WILLIAMSON COUNTY, TEXAS

CHANGE ORDER NUMBER: 1

Project:	<u>151FB102</u>
Roadway:	<u>CR 245</u>
Purchase Order Number:	<u></u>

Change Order No. 1

6" WATER LINE A
PP_04

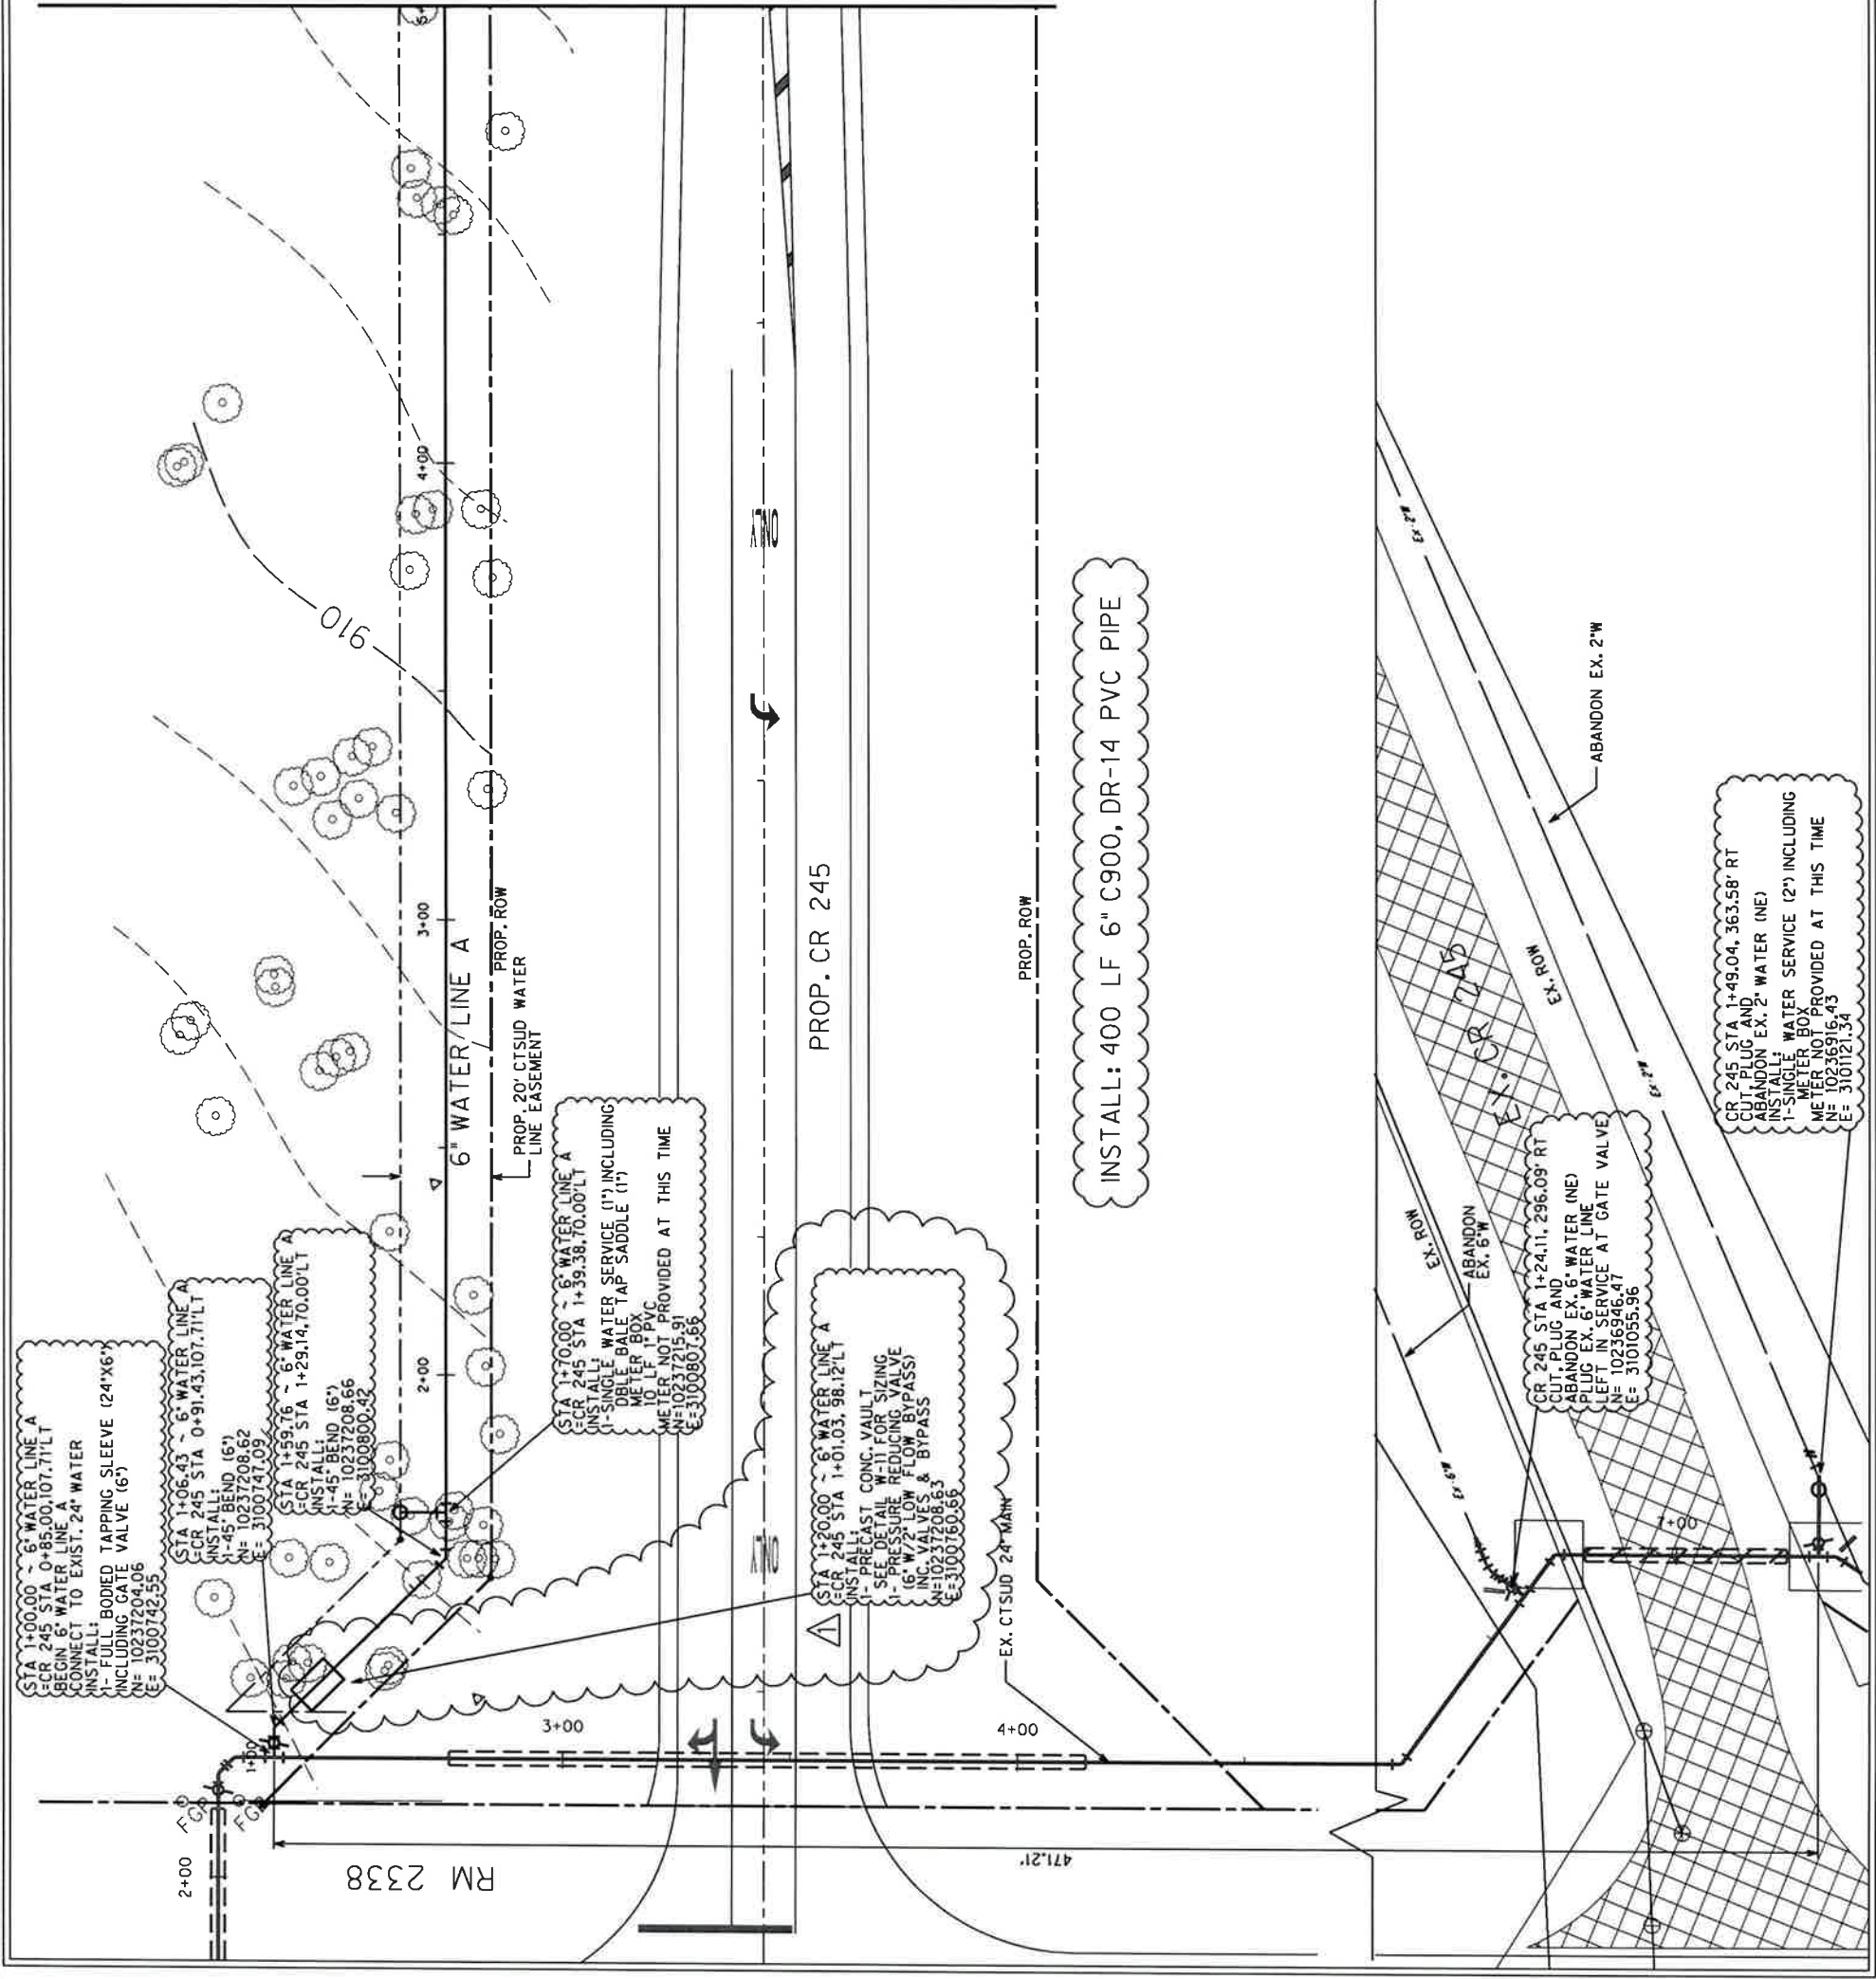
4B: Third Party Accommodation. Third party requested work. This Change Order adds a new Contract item to compensate the Contractor for installing a Pressure Reducing Valve (PRV) on the proposed 6 inch waterline, as required by the City of Georgetown.

2E: Differing Site Conditions (unforeseeable). Miscellaneous difference in site conditions (unforeseeable) (Item 9). The existing waterline was in a different location than shown on the plans, which allowed the Contractor to tie into the existing system at the new location, reducing the contract quantity of new waterline required to be installed.

PROJECT No.	AVD - 28129
DATE	
REVISION	
NO.	1
DATE	4/20/15
DESCRIPTION	ADD VALVE AS SHOWN
BY	
CHECKED BY	
DATE	
PROJECT No.	AVD - 28129
DATE	
REVISION	
NO.	1
DATE	4/20/15
DESCRIPTION	ADD VALVE AS SHOWN
BY	
CHECKED BY	
DATE	
PROJECT No.	AVD - 28129
DATE	
REVISION	
NO.	1
DATE	4/20/15
DESCRIPTION	ADD VALVE AS SHOWN
BY	
CHECKED BY	
DATE
